TOWN OF PLAINFIELD PLAN COMMISSION REPORT

DATE: 02-05-2024
CASE NO.: [DP-23-095](#)
PETITIONER: Thomas English Real Estate
REQUESTED ACTIONS: Architectural and Site Design Review for a 10,500 +/- square foot daycare
LOCATION: Meijer Subdivision Outlot 1
PARCEL SIZE: 3.1 acres+/- (1.3 +/- after subdivision)

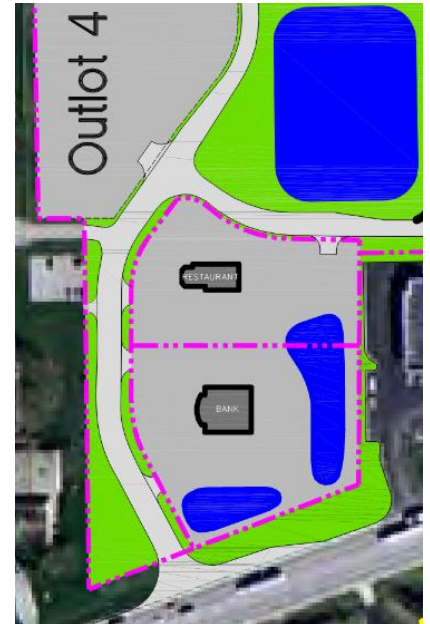
DP-23-095 proposes two drives, consistent with the assumptions made for the lot during the original traffic analysis, as generally illustrated to the right.

Compared to the TIS, the primary drive connecting to Meijer Drive is proposed approximately 50' north. Staff has expressed concern to the Petitioner that this may crowd traffic movements at that drive, given the proximity to the existing Interior Drive intersection and the expected future drive that will serve Outlot #4.

Staff made a suggestion to the Petitioner to consider a Right-In only drive for the Meijer Drive connection. No response was offered whether that option was considered. Further, Staff requested a copy of the filing the Petitioner made with Meijer for its approval. This was not provided, though a response indicated that Meijer is expected to respond to the Petitioner review request by February 7th.

Site restrictions such as an underground stormwater pipe easement, building placement, and parking needs have been considered in laying out the drive connections. While not optimum, it is Staff's opinion that the nature of the Interior Access Drive (i.e. low speed) does not create enough of a safety concern to be a serious design drawback, particularly if the Meijer approves of the site (expecting they will be concerned with how Outlot 4 might be impacted). Still, whether the drive placement is appropriate should be considered amongst other factors when the Commission renders its decision.

Lastly, note that Staff will require a formal submission of the Meijer approval as part of any civil plan approval.
